Re: Minor Project Refinement No. 17 for the TL 6975 San Marcos to Escondido Project

TL6975 San Marcos to Escondido 69 kV Project CPUC Minor Project Refinement Form

**TL6975 SAN MARCOS
to ESCONDIDO PROJECT**
MPR-17
Additional Work Areas
San Diego County, CA

MPR-17 PHOTO LOG

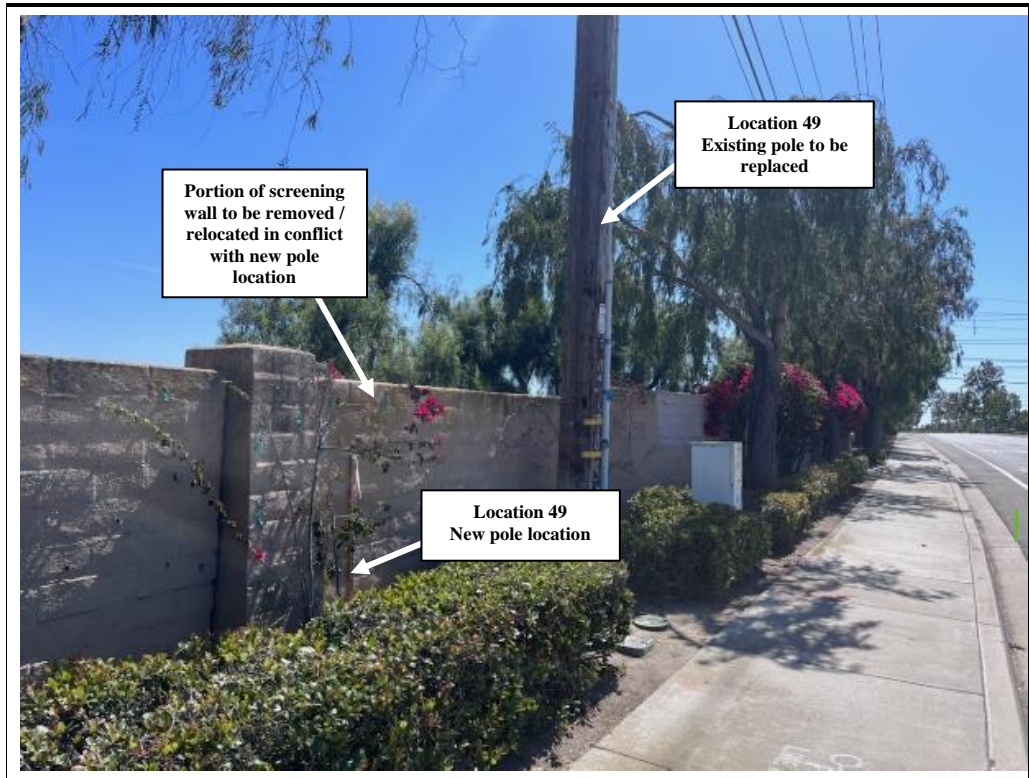
Photograph 1:
View of Location 49 from Palomar Airport Road. The portion of the screen wall in conflict with the new pole location at Location 49 will be removed and replaced.
Facing: Southwest

Photograph 2:
View of the revised permanent and temporary work area at Location 49 and the additional requested work area (WA 49). The relocated screening wall will be installed within the previously approved work area for Location 49.
Facing: South
